A096474

Response to comments received from Regulatory Officer, Environmental Health (Mr Mark Moss) at Havant Borough Council (HBC) received on 19th January 2021 regarding the submitted Noise Assessment by Tetra Tech (formerly WYG) (ref A096474 dated 20th May 2020) for planning application reference APP/20/00441.

Figure 1.1 Demonstration of masking from buildings

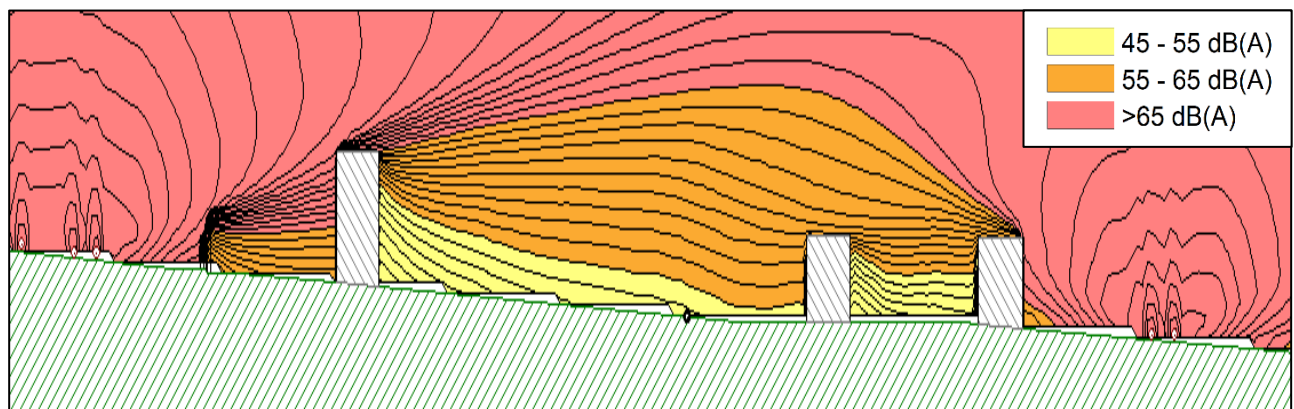
- a. *Whilst the ground and first floors of the apartments (if these are to be apartments in the shadow of the suggested western boundary mitigation measure), will potentially benefit from the proposed bund/acoustic fence mitigation measure (total height of 4.8 metres) and other proposed measures suggested in the windows closed, the top floors of the 3 storey apartments nearest the A3M are unlikely to enjoy the same benefits, without potentially additional mitigation measures, and little likelihood of anyone being able to enjoy the benefits of open windows on any level, especially at night. Also the LAmax levels at 8 metres are likely to be higher.*

It would appear that the number of LAmax events potentially exceeding 80 dB at nearest facades to the A3M (although the number of such events is not provided) especially at night, is likely to exceed 20 events a night, and would potentially lead to sleep disturbance, with windows cracked open. More detail especially in this regard would be necessary in any Acoustic Design Statement.

At this Outline application stage, there is no detailed layout available to inform an Acoustic Design Statement for the proposed development site. However, the Developer is committed to employ the principles of good acoustic design referenced in ProPG, which will be confirmed and implemented at detailed design stage. Where appropriate, the design will aim to position rooms of lower sensitivity (i.e. bathrooms, kitchens, storage) on the most exposed building façades overlooking the A3M and Hulbert Road, to reduce the likelihood of disturbance in sensitive rooms.

To achieve the suitable internal criteria, it is necessary that windows remain closed and alternative means of ventilation (such as MVHR) will be provided across the site. Windows will not be sealed, and residents may choose to open the windows whilst accepting that internal noise may not meet the internal performance criteria.

It is proposed that the development will include a combination of openable windows with enhanced glazing and mechanical ventilation, to provide residents with suitable options for acoustic and thermal comfort, as required. In combination with the internal layout measures outlined in the previous paragraph, the design will maximize the number of noise-sensitive rooms within the development that will benefit from natural ventilation within the acoustic 'shadow-zone' generated by the building structures, thus enabling thermal comfort within living areas while minimising noise disturbance. A cross section demonstrating how this can be achieved is presented in Figure 1.1 below.

Figure 2.1 Speculative layout with external receptors

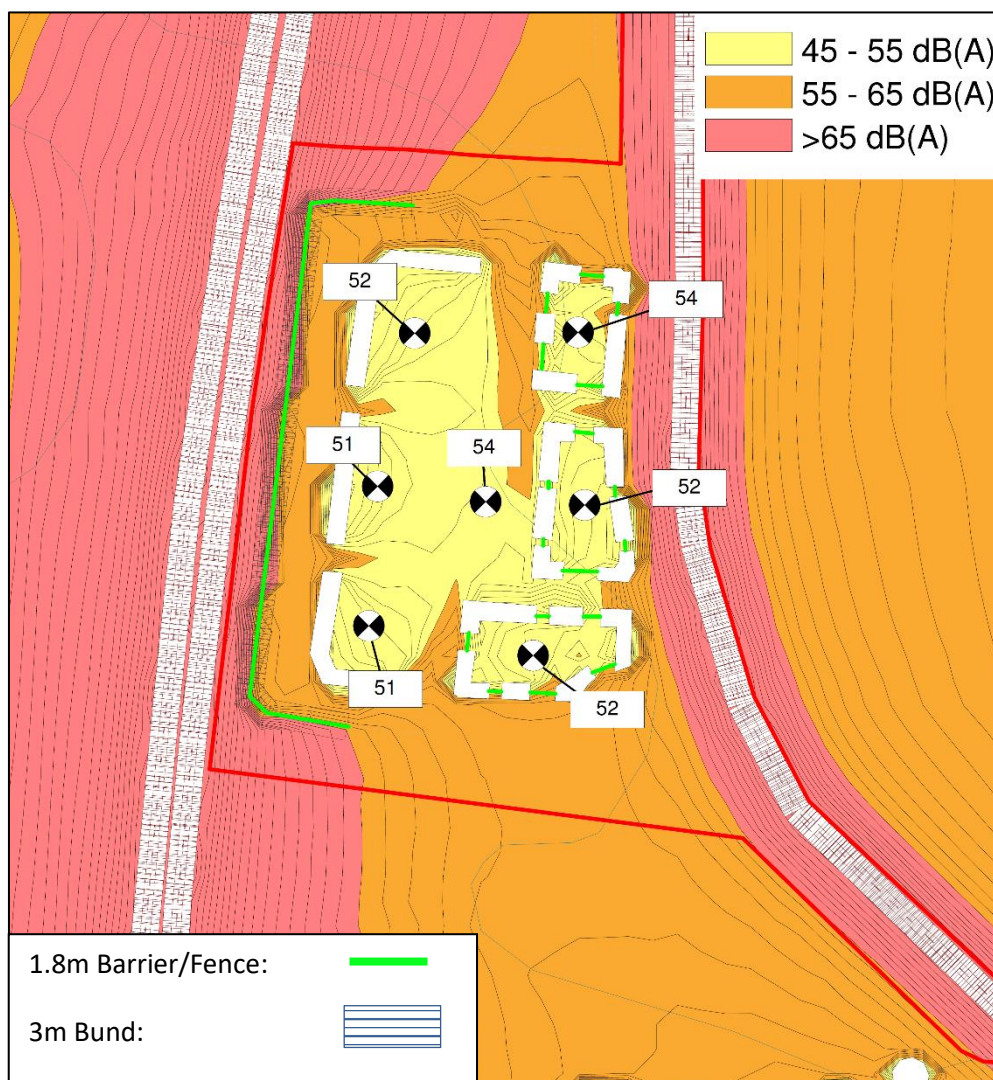
- b. Whilst the internal amenity areas can potentially meet BS8233:2014 criteria with the mitigation measures being proposed (again with windows closed i.e. sealed facades), I still have concerns related to the external amenity areas.

[...] We would advise that in this particular case, the upper guideline value of 55 dB L_{Aeq} (16 hr) needs to be met at all external amenity areas.

[...] the external amenity areas noise levels are depicted as being between 55 – 65 dB(A) at the rear of the properties nearest the bund on the western boundary and in excess of 65 dB(A) for those gardens backing onto the Hulbert Road.

Will close boarded garden fences suitably mitigate against these levels going forward?

In combination with the proposed acoustic bund/barrier detailed in the assessment, building structures will front onto both the A3M and Hulbert Road, to provide screening to ground floor communal external amenity areas, with the addition of close boarded garden fences where necessary.

Tetra Tech acknowledges the requirement from HBC to design toward an upper external noise limit of 55dB $L_{Aeq,16 \text{ hour}}$. For reference, with a speculative layout plan as outlined in Figure 2.1, all receptor locations in communal external spaces will be capable of meeting the limit of 55dB $L_{Aeq,16 \text{ hour}}$.
